CONSULTANT ADVICE

Date	23 May 2018
Project	Gledswood Hills Public School
Project Number	16344
CA Ref.	CA-01
To	Marco Luci
Company	Perumal Pedavoli Architects
From	Dishana Liang
Subject	External Paths of Travel

External paths of travel have been reviewed against the BCA requirements and AS 1428.1(2009).

**GROUND FLOOR
SITE PLAN**

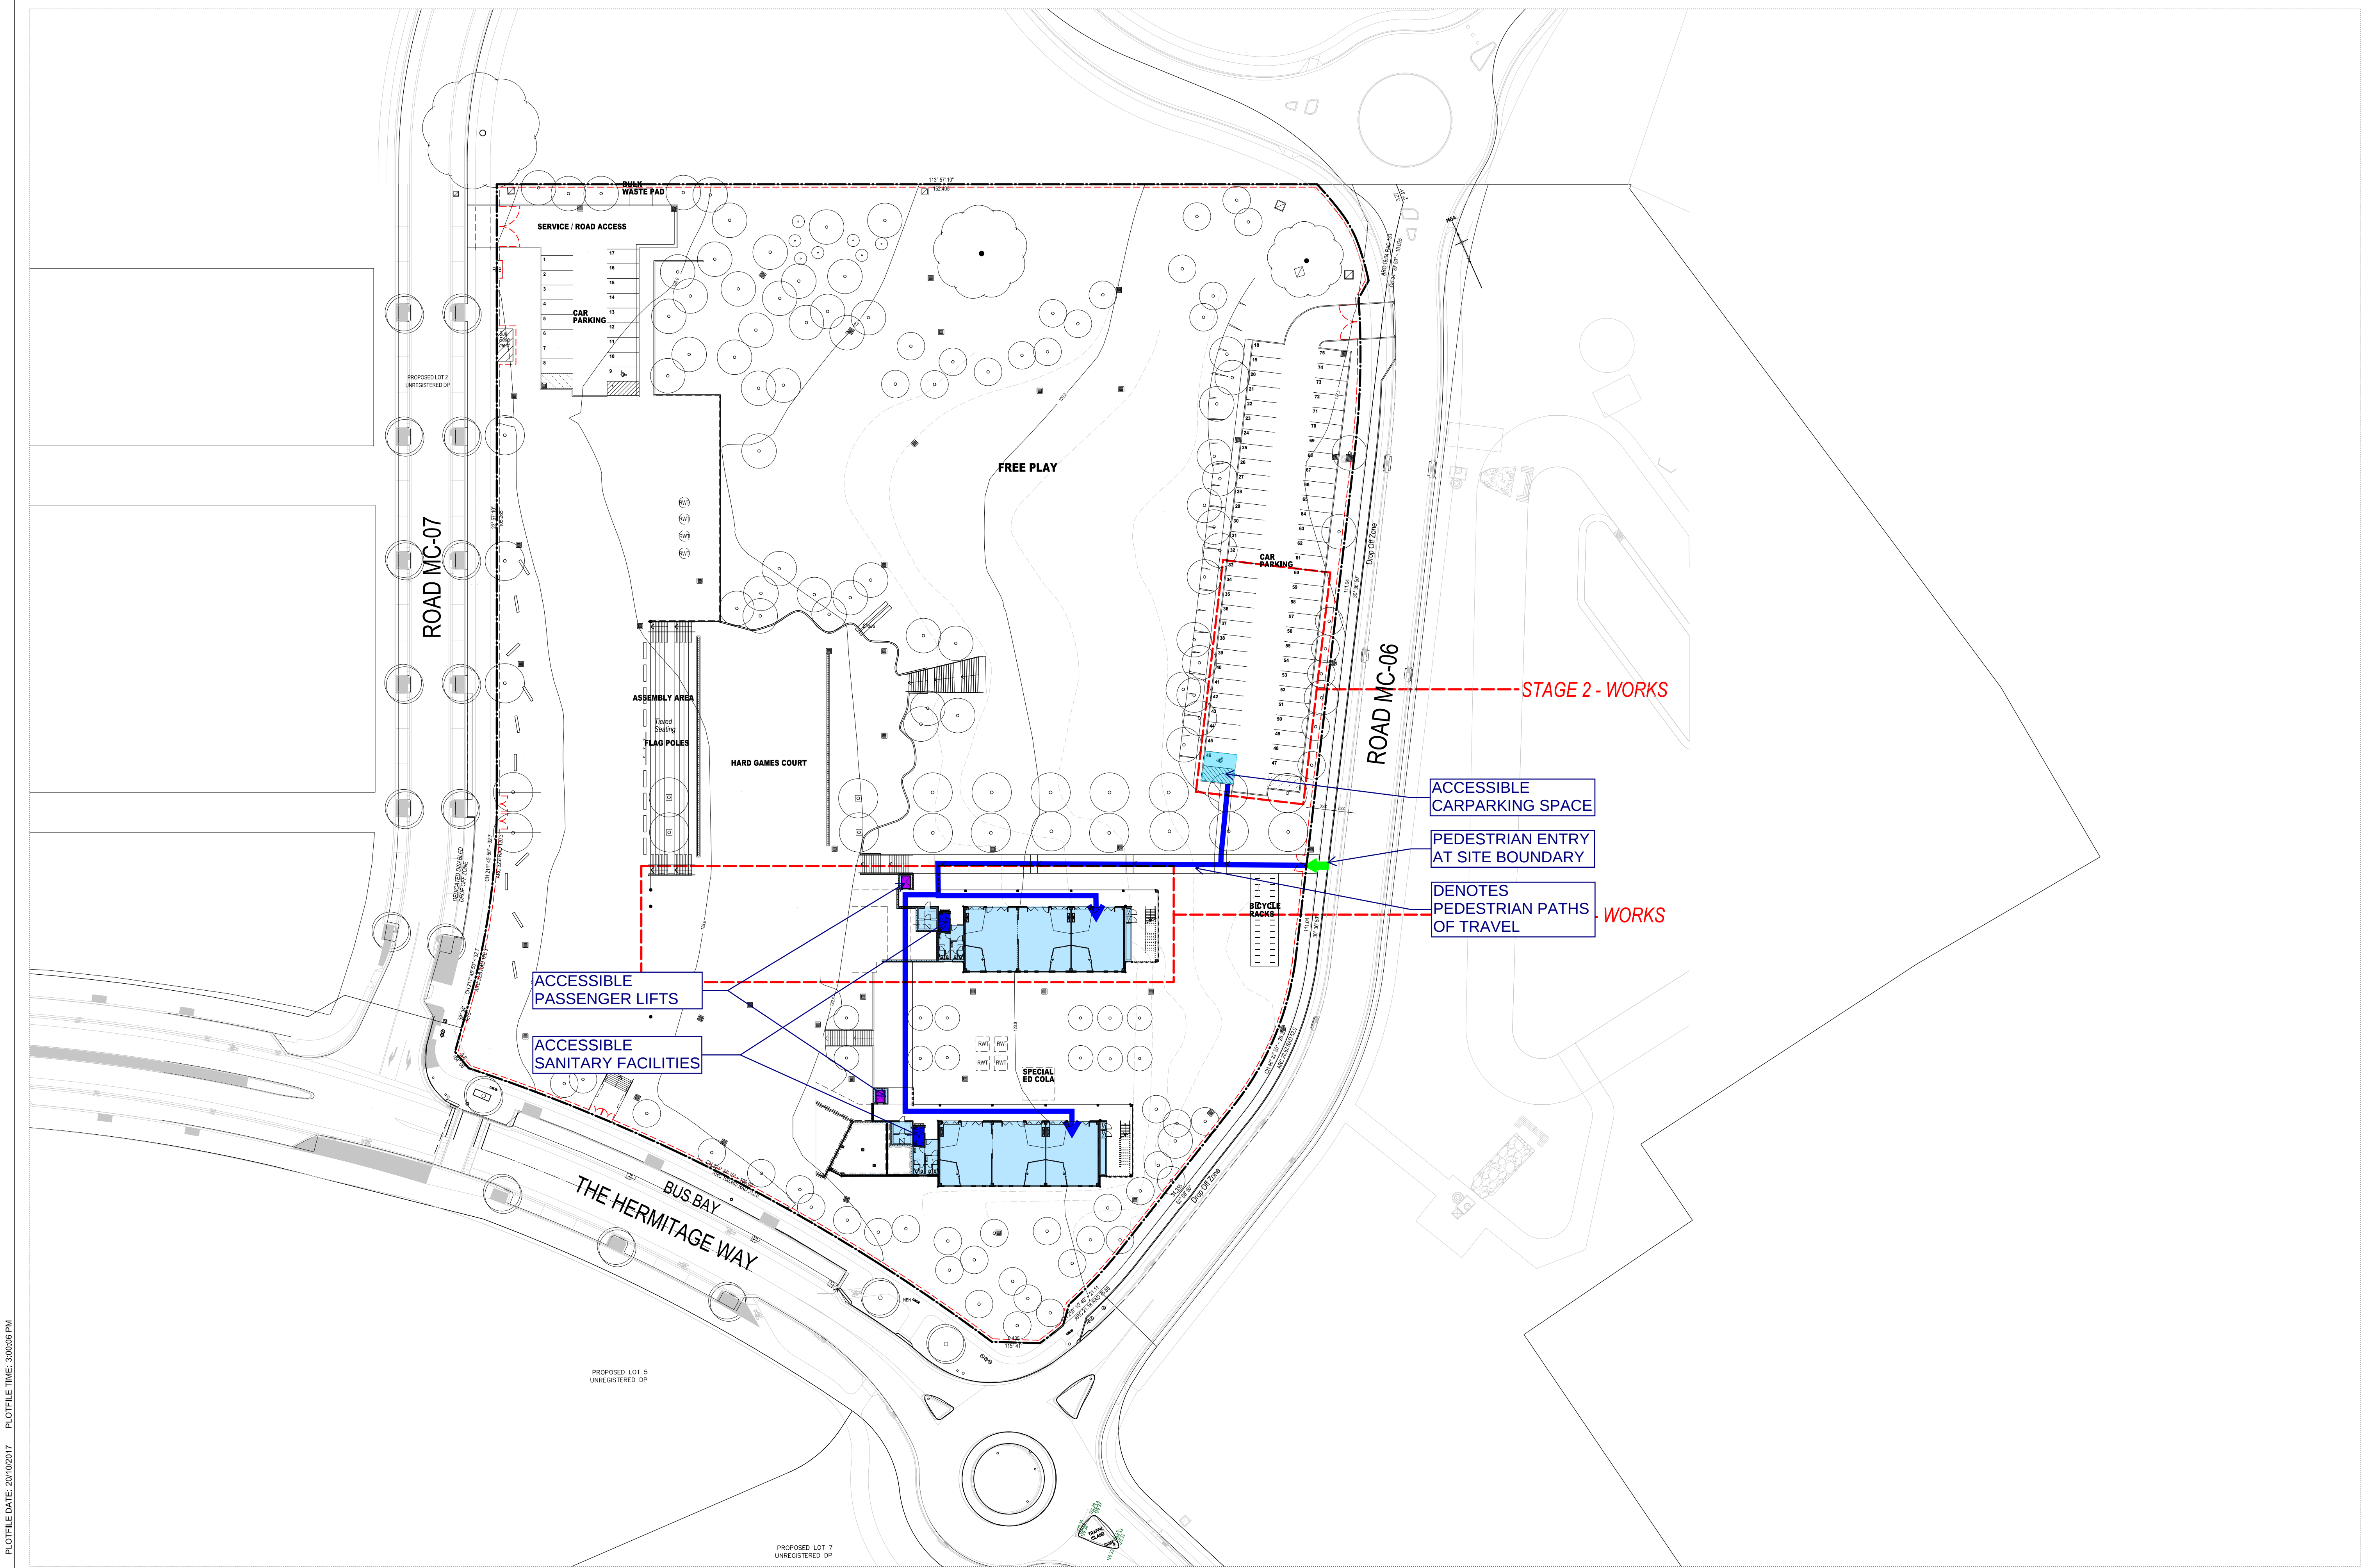
The current documentation provides appropriate paths of travel to connect all buildings from two of the three pedestrian entries at the allotment boundary, from accessible carparking spaces at both carparks, as well as between all buildings. Refer attached marked plans indicating locations of accessible pedestrian paths of travel.

In relation to the pedestrian entry points from the allotment boundary, it is noted that the site is provided with three pedestrian entries, one off 'Road MC-07', one off 'The Hermitage Way' and another off 'Road MC-06'. The pedestrian entry off The Hermitage Way will not be accessible due to provision of stair access only. It is noted that there is a significant fall across the site which has led to the provision of stair access. A performance solution will be developed to address this entry on the basis of the following:

- Distance between pedestrian entry which is not accessible (off Hermitage Way) is not a significant travel distance from the accessible entries (approximately 66m). This is comparable to the 50m distance permitted between accessible and non-accessible entries into a building. It is considered that the maximum distance to travel from the non-accessible site entry to an accessible one is acceptable.
- It is noted that parents or children will generally be familiar with the school site and will utilise the entries which best serve their needs.
- The general drop off zones are located off Road MC-06 and Road MC-07, where accessible site entries are located.
- All carparks are provided with accessible path of travel.

A formal performance solution report will be prepared to demonstrate compliance with relevant Performance Requirement DP1 to confirm that access will be provided to the degree necessary. This report will be submitted for review and approval by the Principal Certifying Authority.
